P&WC S.B. No. 28401

TURBOSHAFT ENGINE IGNITION EXCITER - REPLACEMENT OF

Feb 11/2021 PW200-74-28401 Cover Sheet

Ignition Exciter - Part Progression Figure 1

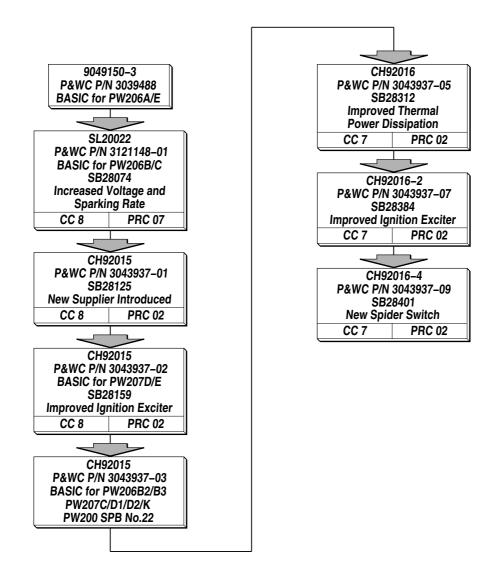
Replace the ignition exciter with one that has an available spider switch.

Replace the ignition exciter with a new one.

New P/N	Keyword	Old P/N	<u>Qty</u>	Est. Unit List Price (\$US, 2021)	Instructions Dispositions
	Ignition Exciter (0AFL4) P&WC P/N 3043937-07	CH92106-02	1		(A)(B)
CH92106-04	Ignition Exciter (0AFL4) P&WC P/N 3043937-09		1	Quote	(A)

- (A) TWO WAY INTERCHANGEABLE (ATA200 Explanation Code 02): The old or the new parts can replace the old or the new part.
- (B) Discard the part if it is unserviceable. Return a serviceable part to stock.
